25/30/40/50/60 FourStroke Upper Motor Mount Bolt Torque Specification

Models Covered	Part Number
25 BigFoot FourStroke	854785R2
30/40 FourStroke EFI	883064R02
40 FourStroke 3 Cyl	899974
50/60, 40/50/60 BigFoot, 40 Jet EFI FourStroke 4 Cyl.	866917

31593

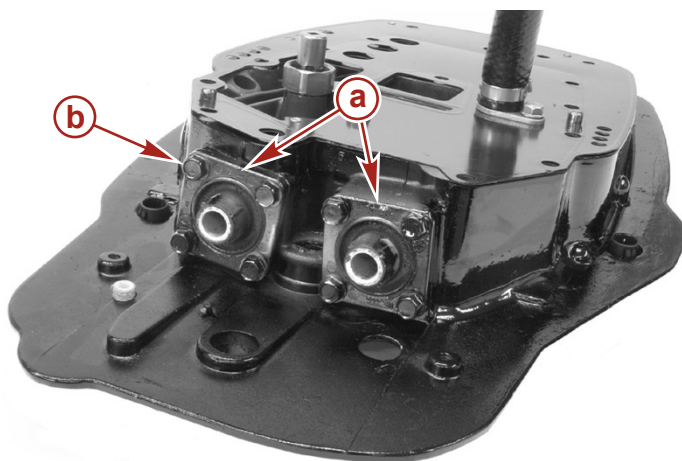
Mercury Marine has updated the torque specification for the upper motor mount bolts. The new values need to be reflected in the above service manuals. Use these revised specifications when torquing the upper motor mount bolts on the above mentioned models.

NOTE: If service procedures require removal of the upper motor mount bolts, replace the bolts prior to reassembly. Failure to replace the bolts may result in a reduced clamp load between the upper motor mount and the adaptor plate.

- a - Upper mount (2)
- b - Bolt (M6 x 20) (4 per upper mount)

Description	Nm	lb-in.	lb-ft
Upper mount bolts (M6 x 20)	12	106	-
